Access Compliance Report Public Rights-of-Way (Curb Ramps)

Main Street: GILBERT_ST Cross Street: W_RANDOM_DR Location: SW

ADA ID: RPRK210927135109 Ramp Type: Type 1 - Perpendicular Diagonal Initial Pass/Fail: Fail Overall Compliance: No Severity Score: 2

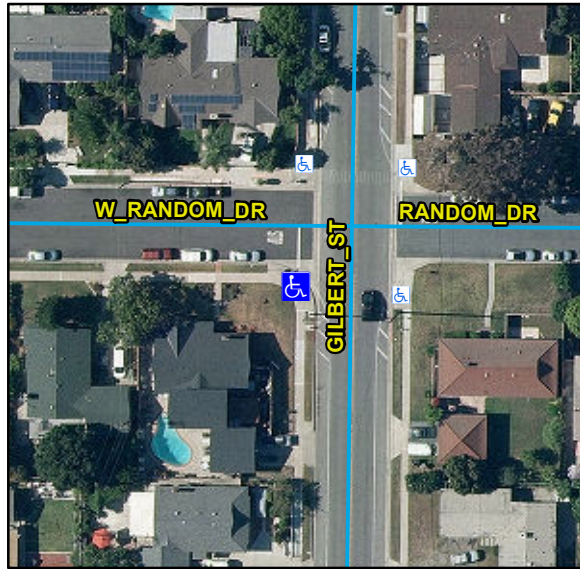
Compliance	Description	Data	Compliance	Description	Data
N/A	Ramp Length (in)	97	N/A	Flare Type LT	
Yes	Ramp Width (in)	48			N/A
Yes	Ramp Run Slope (%)	7.2	N/A	Flare Slope LT (%)	N/A
No	Ramp Cross Slope (%)	2.6	N/A	Flare Traversable LT	N/A
N/A	Landing Present	N/A	N/A	Flare Type RT	
N/A	Landing Length (in)	N/A			N/A
N/A	Landing Width (in)	N/A	N/A	Flare Slope RT (%)	N/A
N/A	Landing Run Slope (%)	N/A	N/A	Flare Traversable RT	N/A
N/A	Landing Cross Slope (%)	N/A	N/A	DWS Provided	N/A
N/A	Landing Movement Obstructed?	N/A	N/A	DWS Contrast	N/A
	Landing Movement Type	N/A	N/A	DWS Length (in)	N/A
N/A	Landing Shared	N/A	N/A	DWS Full Width	N/A
N/A	Clear Space	Yes	N/A	DWS Offset Left (in)	N/A
N/A	Clear Space To Crosswalk (in)	N/A	N/A	DWS Offset Right (in)	N/A
N/A	Marked Crosswalk 1	No	N/A	Marked Crosswalk 2	No
	Crossing 1 Direction	E		Crossing 2 Direction	N
	Marked Crosswalk 1 Width (in)	N/A		Marked Crosswalk 2 Width (in)	N/A

N/A	Ramp Inside Crosswalk 1	N/A	Yes	Ramp Inside Crosswalk 2	N/A
	Crossing 1 Slope (%)	9.2		Crossing 2 Slope (%)	0.2
	Crossing 1 Cross Slope (%)	1.4		Crossing 2 Cross Slope (%)	0.5
N/A	Gutter Ponding	N/A	N/A	Curb Slope	3.2
No	Gutter Lip Height (in)	0.5		Road Run Slope (%)	4
N/A	Gutter Run Slope (%)	N/A		Road Cross Slope (%)	1.9
N/A	Gutter Cross Slope (%)	N/A			
Yes	Overall Surface Condition: Acceptable		No	Perp Joint Present	No
	Cross Gutter Present?	Yes		Spandrel Present?	Yes
	Replace Cross Gutter?	No		Replace Spandrel?	No

Remove & Replace Curb Ramp With Two New Directional Ramps or Equivalent. Grind Gutter Lip.
